## MEMORANDUM

**TO:** Village President and Village Board  
**FROM:** James M. Hogue, Village Planner  
**DATE:** February 10, 2015  
**RE:** Board & Commissions Report for 9/22/14

### **AC - Regular Meeting; 2.9.15 (3 Action Items)**

Drawing Title:  
**EXTERIOR  
 ELEVATIONS**

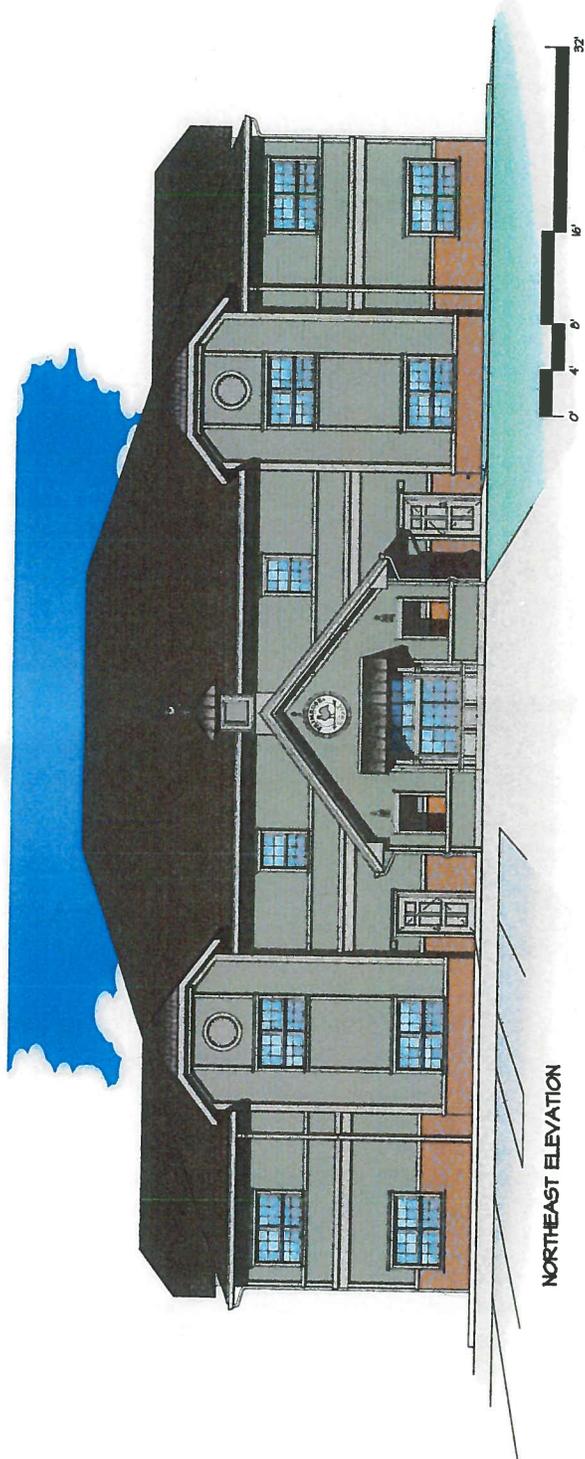
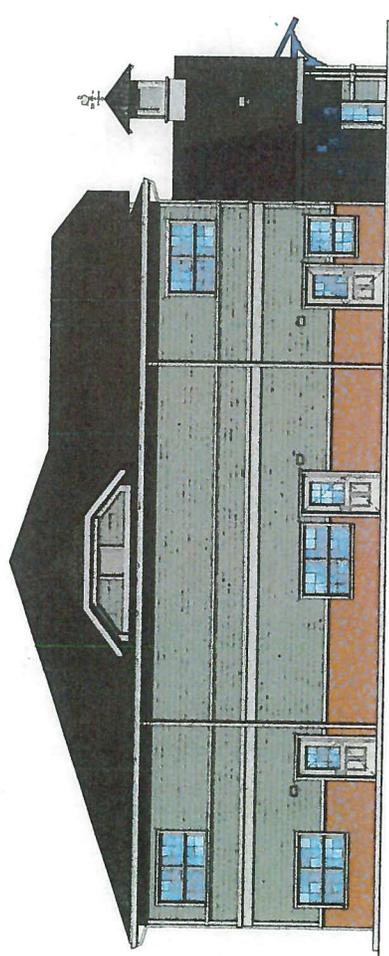
The AC had further concerns with “monolithic” and institutional look of the structure. They noted that alteration of the roof lines may be the most vital and efficient way to deal with these concerns and break up the scale of the building. The AC considered the request in three parts.

- Provide further articulation of the structure to reduce the scale of the structure to provide more of a residential look ;
- Articulate trim board around the structure;
- Project dormers down the north and south side of the building (to break-up window lines)

A motion was made by Commissioner Styer, seconded by Commissioner Closson, to have the petitioner resubmit additional elevations for consideration at the March meeting which addresses the following;
